## **Further setback notes for Lot 4 from Town planner**

**RE: PROPOSED BUILDING PADS  
51-53 DUCIE STREET IN DARRA**

Further to our recent discussions, I can confirm that I have reviewed the proposed 1 into 5 lot subdivision application that is currently before Council.

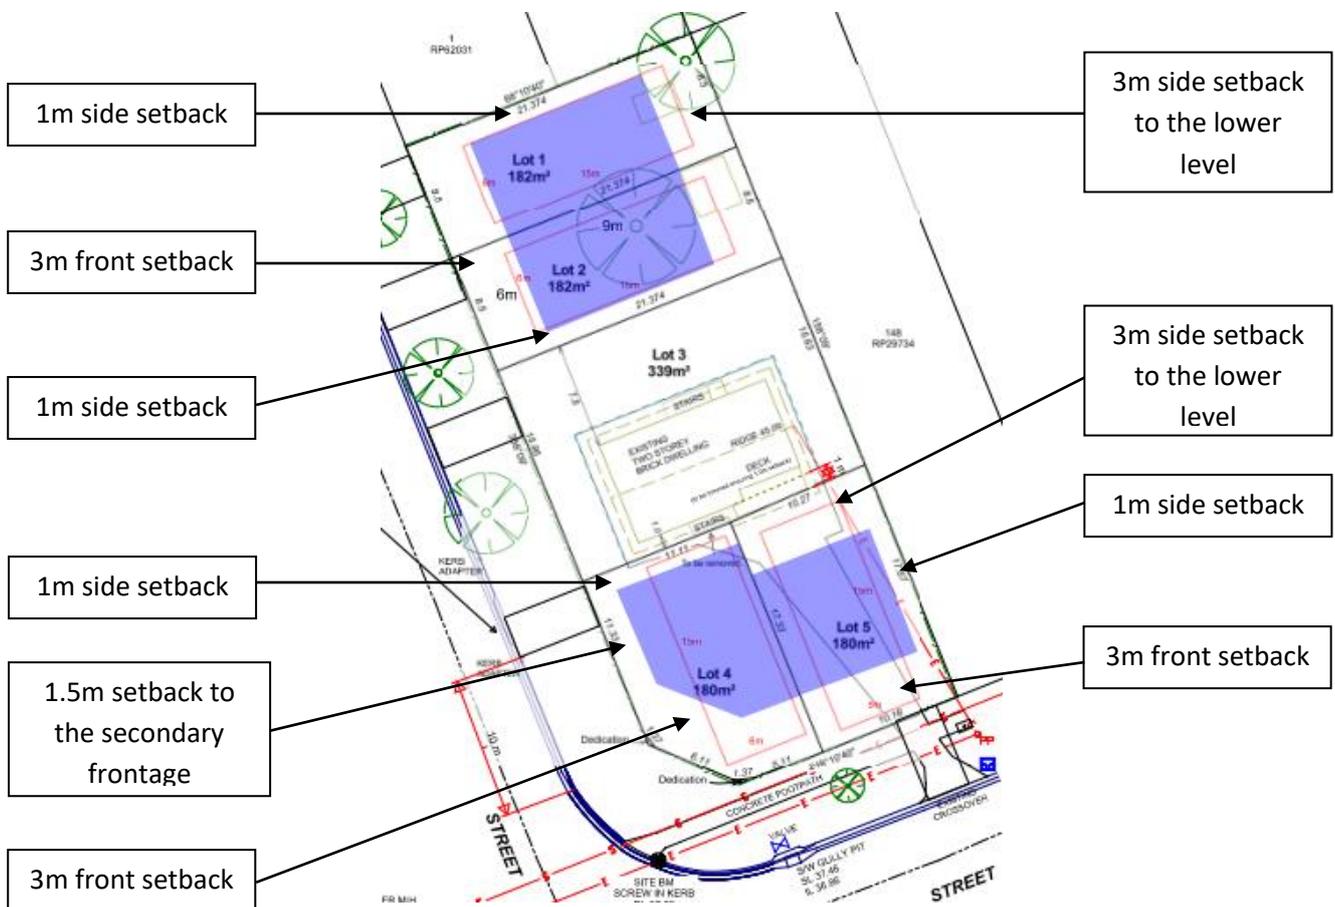
Based on Councils 'as of right' rules (i.e. the Acceptable Solutions), I can confirm that the future allotments could be developed as shown in the image below. Noting that the blue outline represents the potential extent of the building footprints.

The front setbacks shown, relies on lots 2 and 4 being approved for development by the Private Certifier before lots 1 and 5 are developed.

It is also noted that a 5.5m setback is still required between the front boundary and any garages. Also, a 1m clearance is required between any built to boundary walls and any habitable windows on the adjoining allotments.

This outcome could be achieved without any further Council approvals.

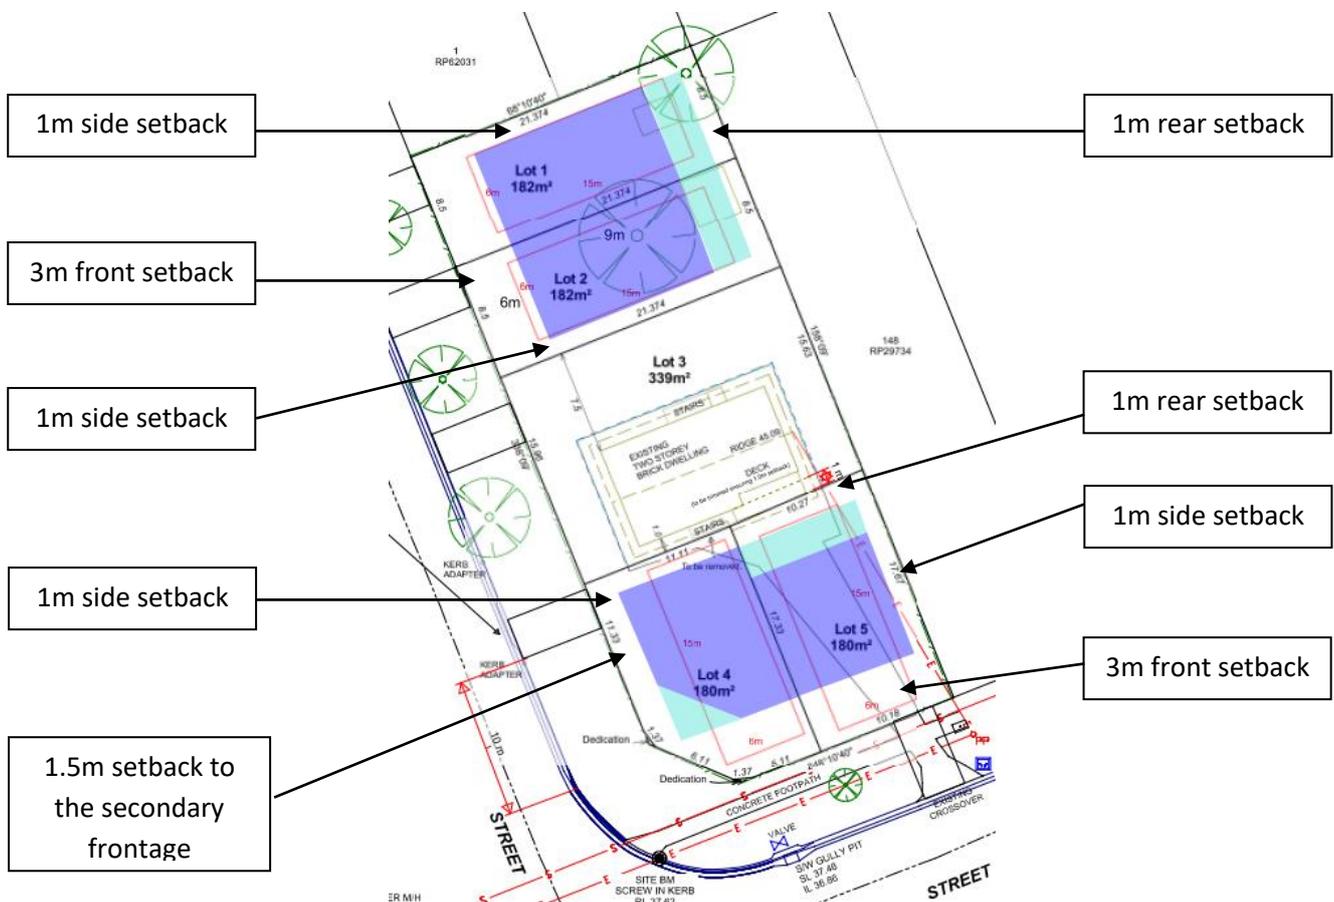
If a purchaser was prepared to lodge a Town Planning application to seek approval for a Performance outcome under the Dwelling House (Small Lot) Code, I believe that Council would support further reduced setbacks.

In particular, I believe that Council would be willing to reduce the setback at the rear of proposed lots 1, 2 and 5 as low as 1m. I also believe that Council would support an extension of the footprint in lot 4 towards the truncated corner, as shown below.

These statements are made on the basis that the rear boundary of lots 1 and 2, is in fact only a side boundary of Lot 148 on RP29734. I.e. pre-subdivision, the expectation was that this could be developed in accordance with the side boundary setback rules.
